P&Z CASE # SP2022-040 P&Z DATE August 9, 2022 CC DATE N/A Approved/Denied

PROJECT NUMBER: SP2022-040
PROJECT NAME: Site Plan for John King Office Park
SITE ADDRESS/LOCATIONS: 1940 N JOHN KING BLVD

CASE CAPTION: Discuss and consider a request by Jeff Carroll of Carroll Architects, Inc. on behalf of Aaron Davis of SBM Real Estates Services for the approval of a Site Plan for an Office Park on a 2.36-acre tract of land identified as Tract 1-2 of the W. H. Baird Survey, Abstract No. 25, City of Rockwall, Rockwall County, Texas, zoned Planned Development District 10 (PD-10) for Commercial (C) District land uses, situated within the SH-205 By-Pass Overlay (SH-205 BY-OV) District, located on the west side of John King Boulevard south of the intersection of John King Boulevard and SH-276, and take any action necessary.

DEPARTMENT	REVIEWER	DATE OF REVIEW	STATUS OF PROJECT
PLANNING	Henry Lee	07/22/2022	Needs Review

EXTERIOR ELEVATIONS

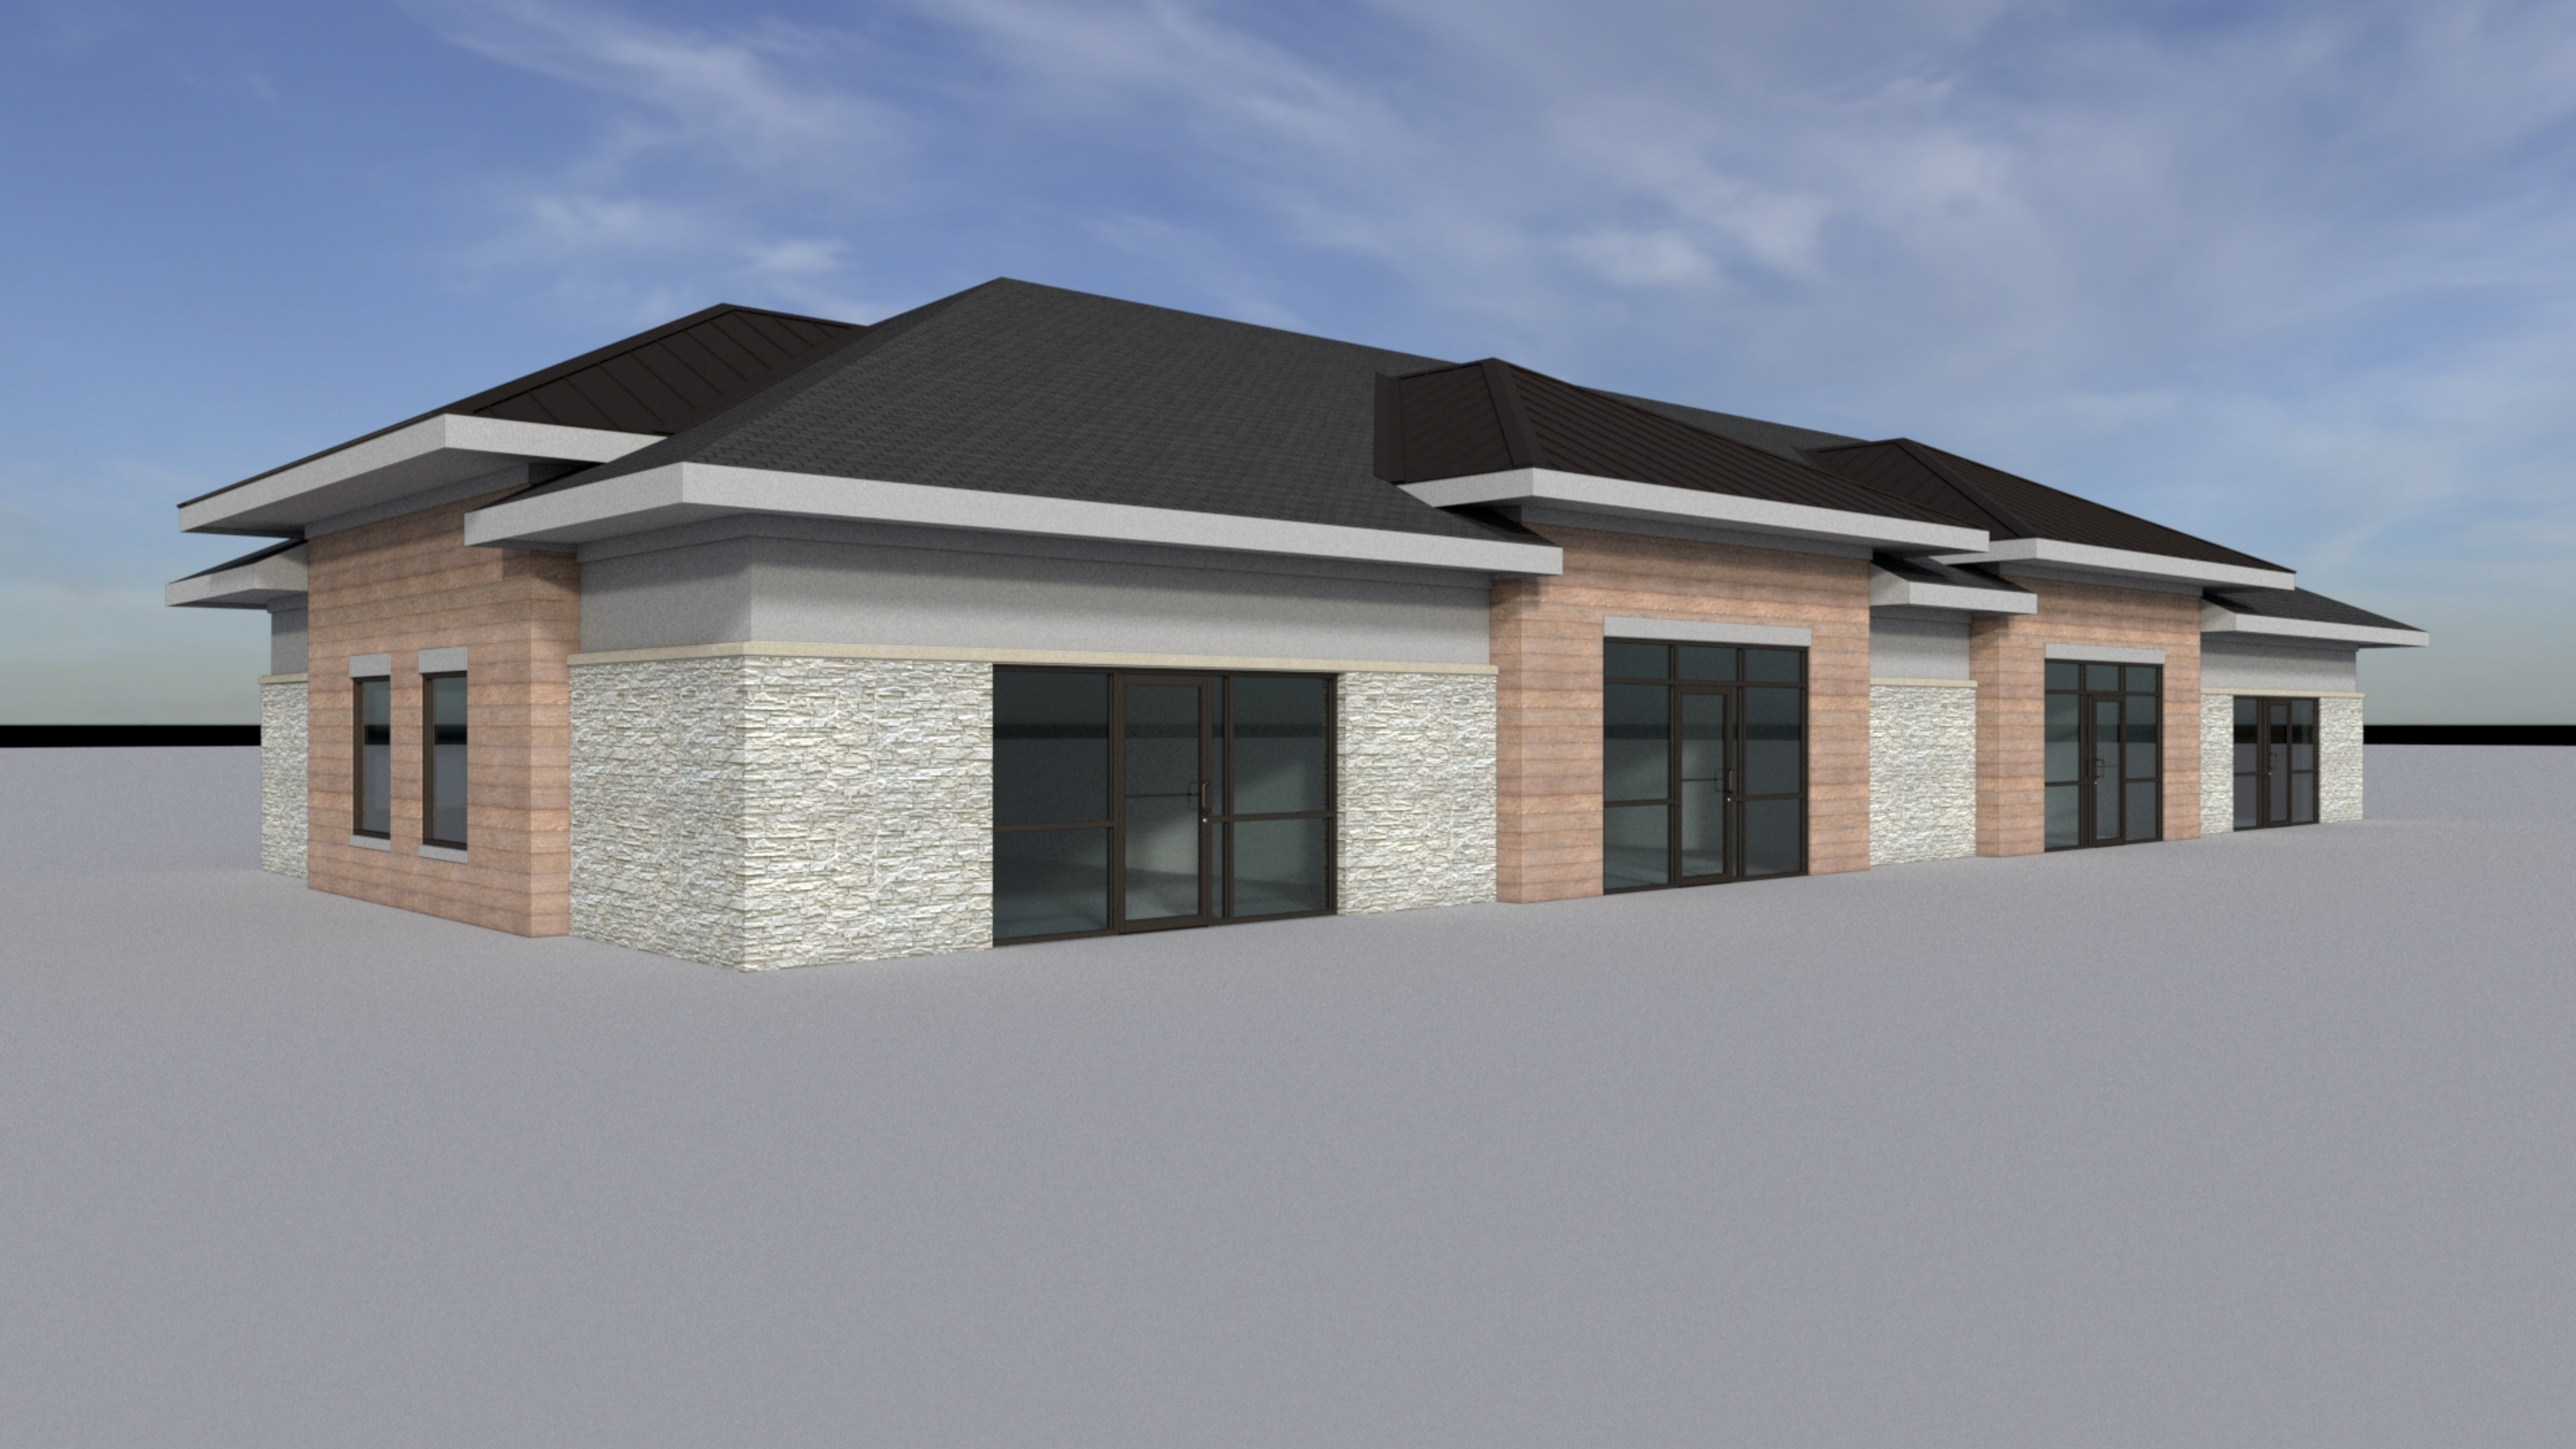
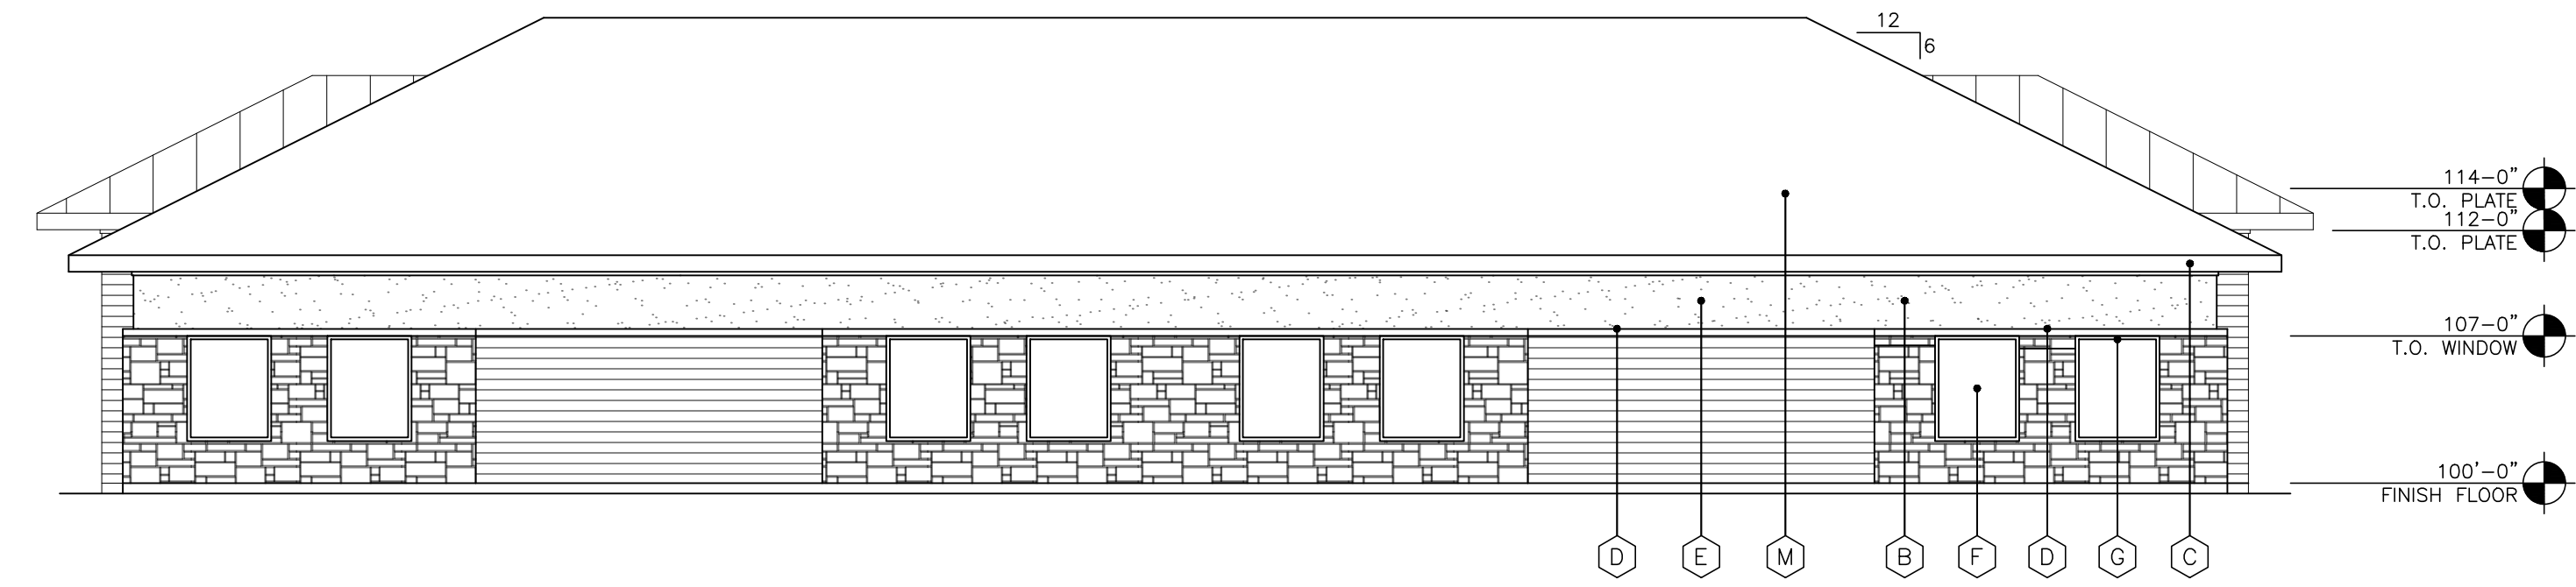
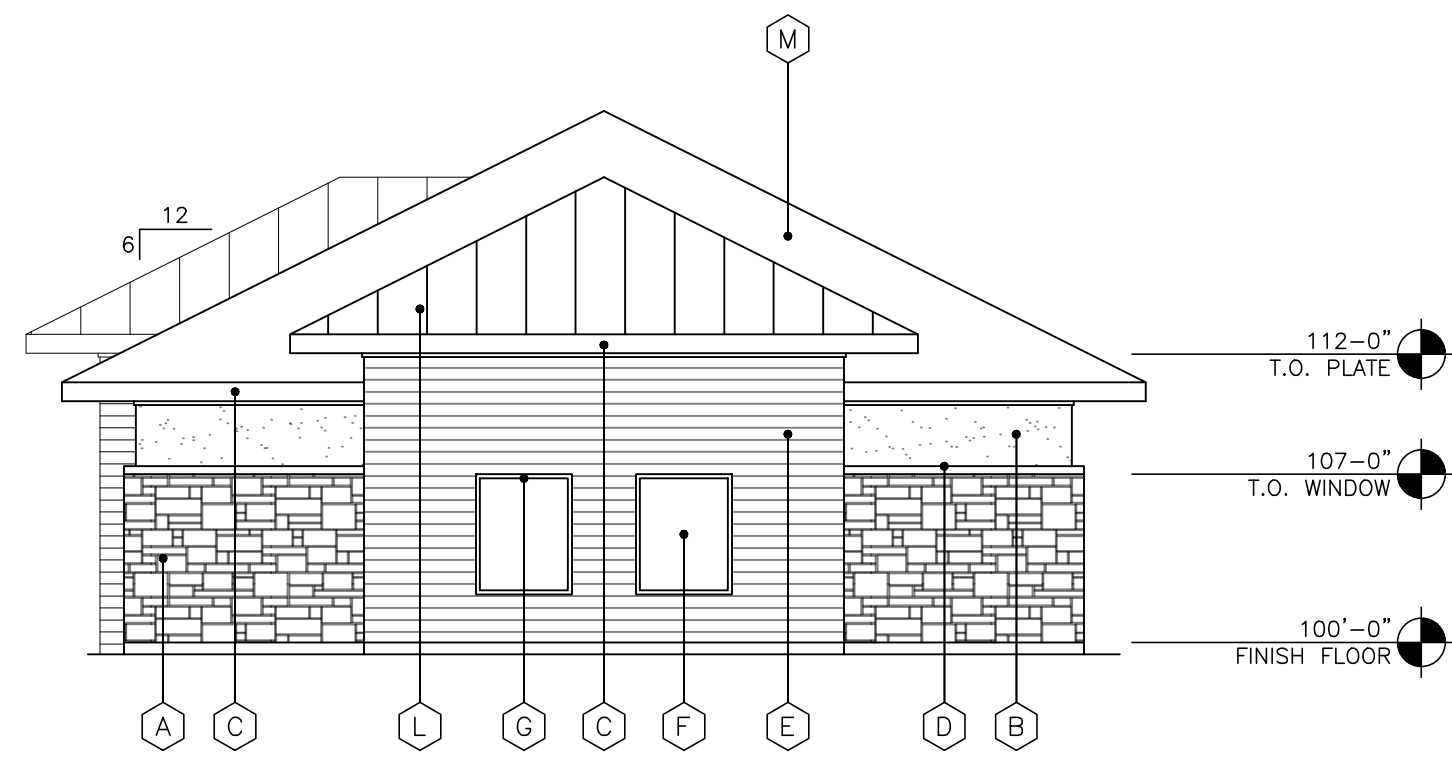
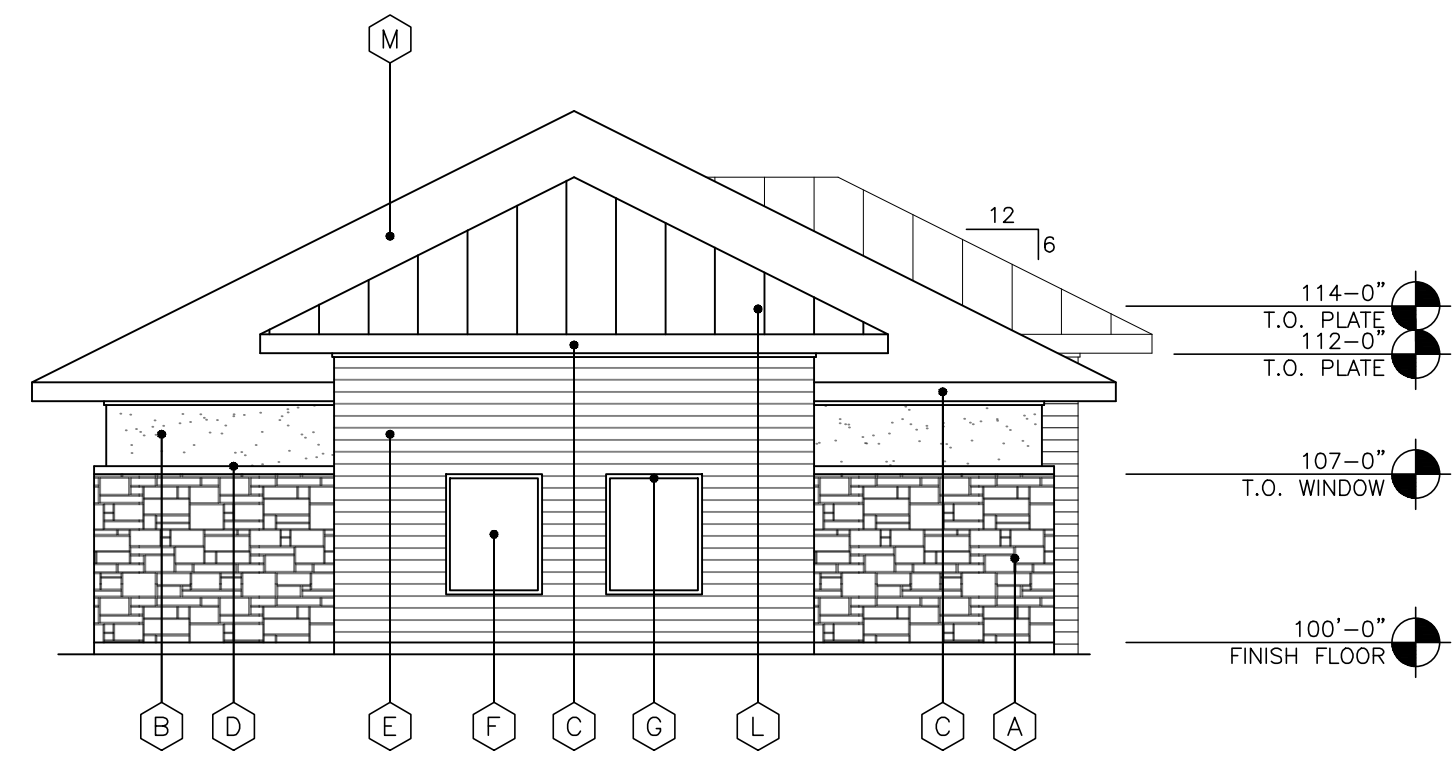
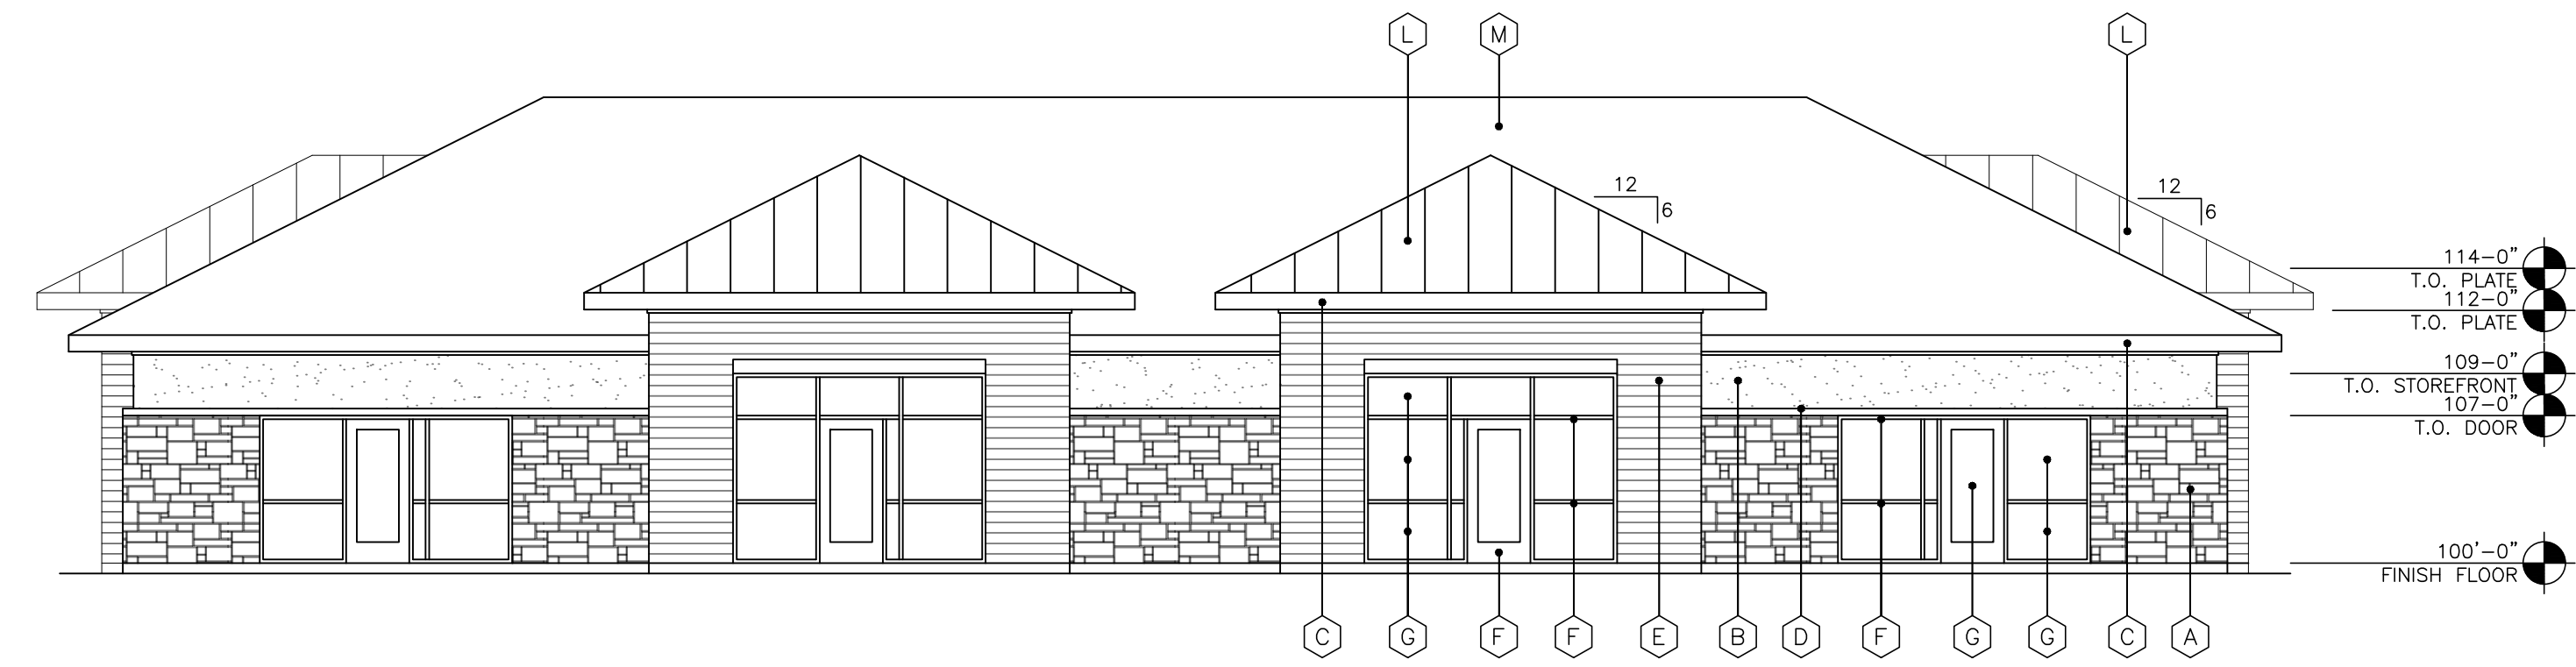
1. Please provide the material percentages on each façade of the proposed building. (Subsection 04.01, of Article 05)
2. 20% natural or quarried stone is required on each façade of the proposed building. (Subsection 06.02. C, of Article 05)

3. 90% masonry materials are required on each façade of the proposed building. (Subsection 06.02. C, of Article 05)
4. Please provide more information on the proposed materials. An EIFS finish on the stucco is not permitted. (Subsection 04.01, of Article 05)

I.14 Staff has identified the following variances associated with the proposed request: [1] primary articulation, and [2] architectural elements. Should you decide to request these items as variances, please provide a letter that lists the variances, why they are being requested, and the subsequent compensatory measures. For each variance requested you
